UNITED STATES PATENT AND TRADEMARK OFFICE

**Advisory Action
Before the Filing of an Appeal Brief**

Application No. 10/705,591	Applicant(s) LEE ET AL.
Examiner Jason M. Han	Art Unit 2875

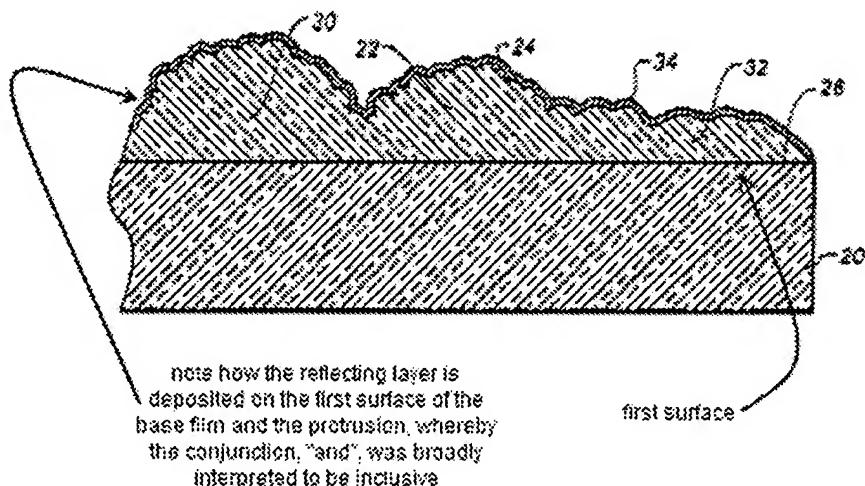
Applicant's primary argument, "Kaminsky does not disclose a reflecting layer deposited on the first surface of the base film and the protrusion", is not considered persuasive, whereby the Examiner rendered a broad interpretation of the claim language as stated by the Applicant [MPEP 2111]. At present, the prior art remains commensurate to the scope of the claim, since Kaminsky (U.S. Patent 6,898,012) teaches a reflecting layer being deposited on the first surface of the base film and the protrusion in combination [note drawing below].

With regards to Independent Claim 1, Kaminsky discloses a reflector including:

- A base film [Figure 1: (20)];
- A protrusion [Figure 1: (22, 24, 30, 32)] provided on a first surface, whereby the first surface is substantially flat; and

- A reflecting layer [Figure 1: (34)] deposited on the first surface of the base film and the protrusion, for reflecting light generated from a lamp [Figure 2: (18)].
